# ADDENDUM No. 1

## ITB No. 4525

### CREST BUENA VISTA WASHINGTON WATER MAIN PROJECT

SHEET No. **40 OF 46**

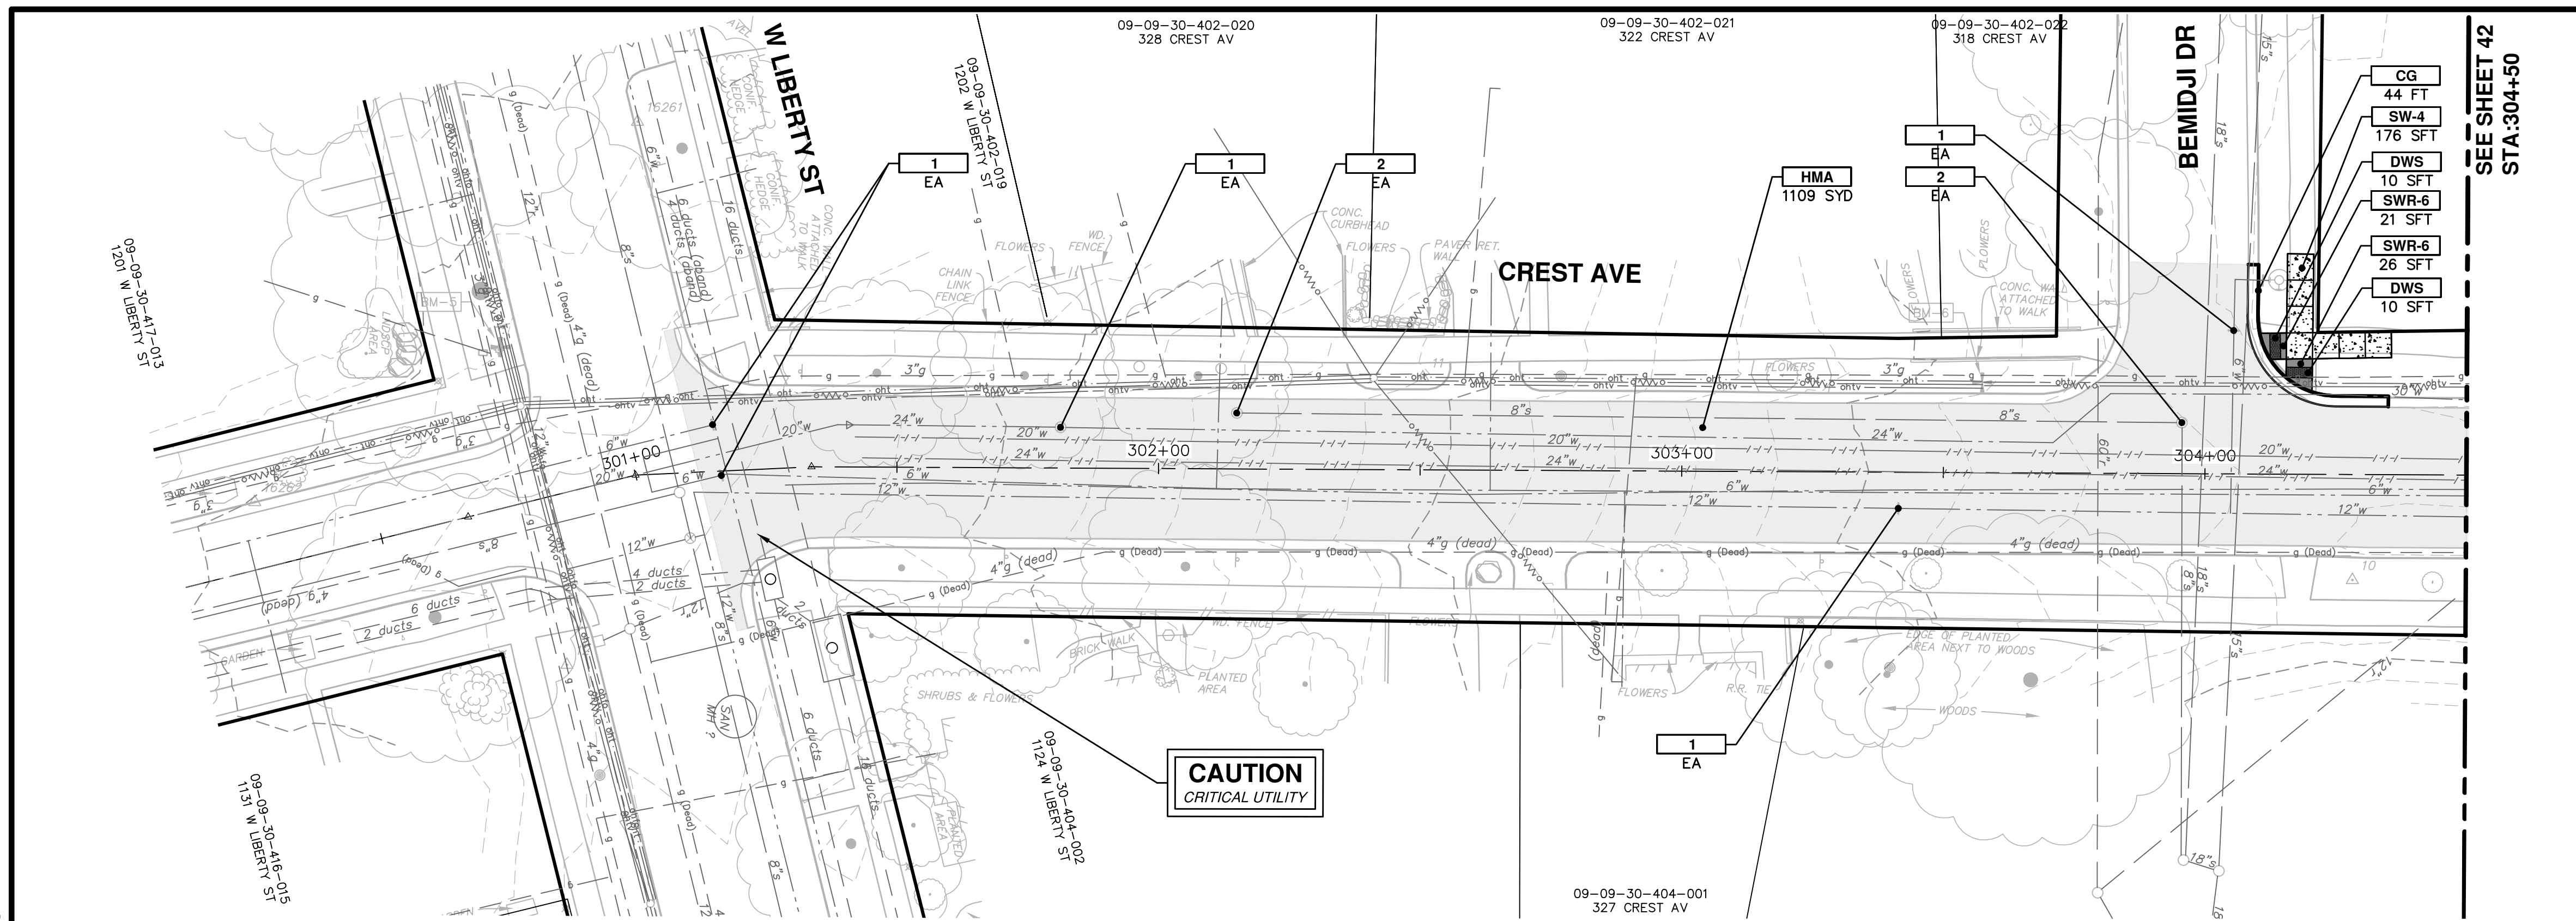
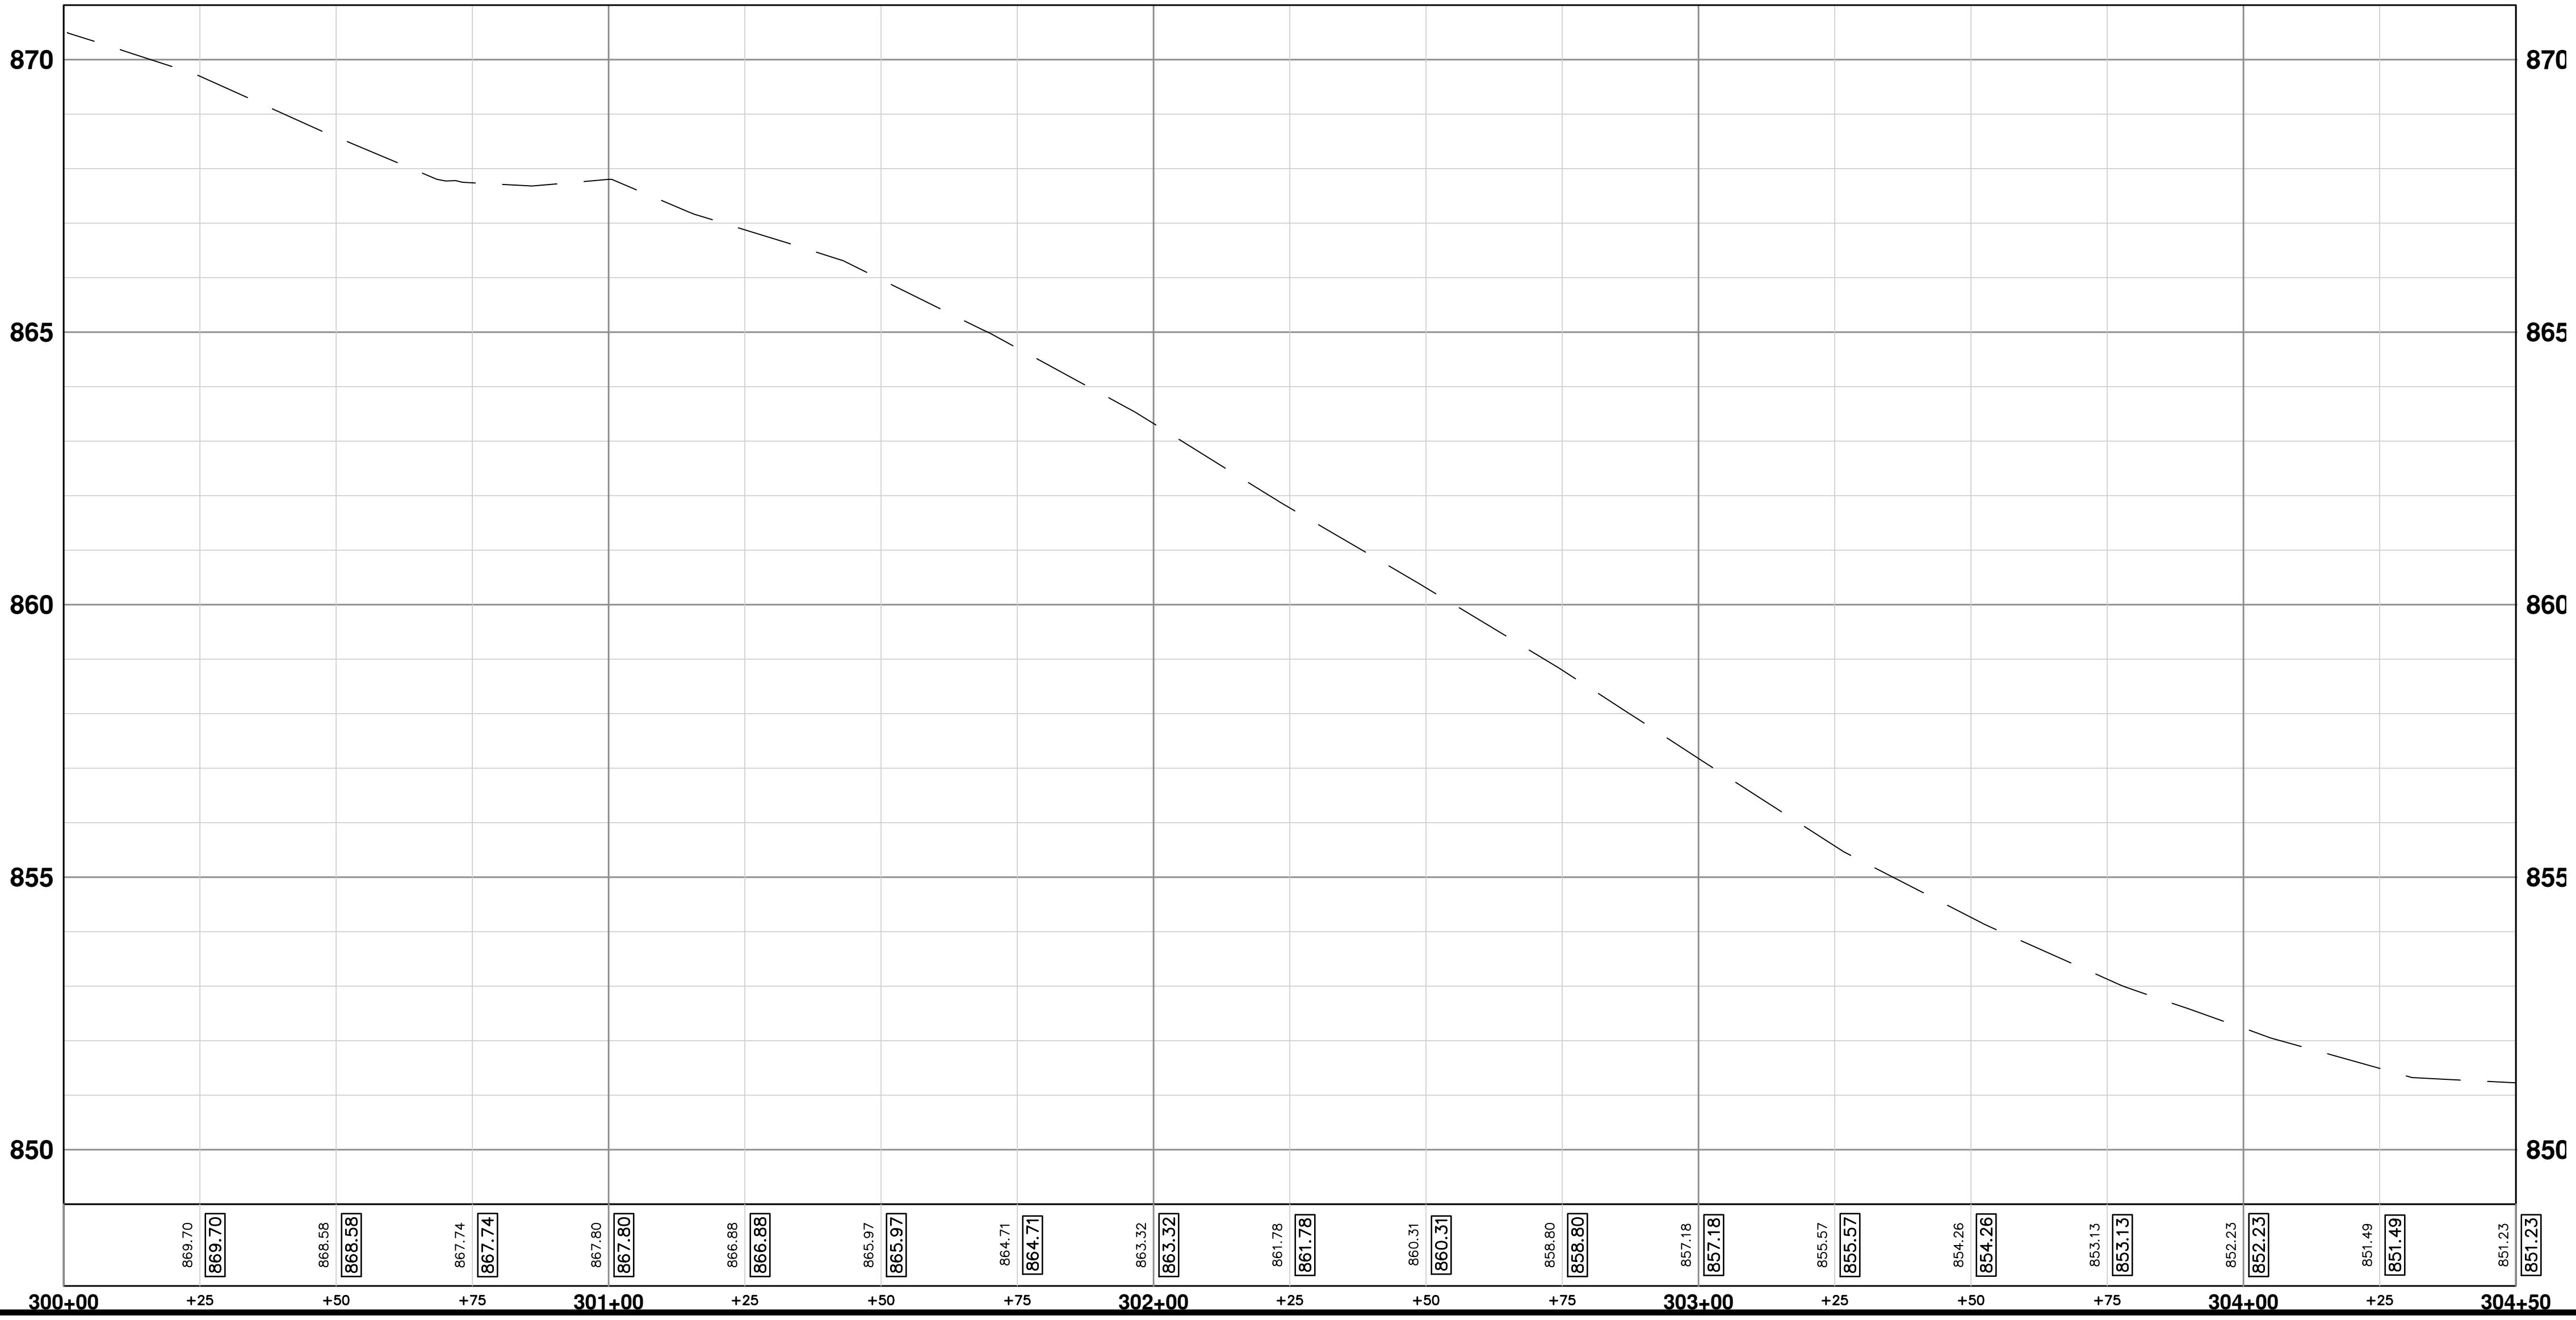
On plan sheets 39-45, structure and gate box adjustments were added.
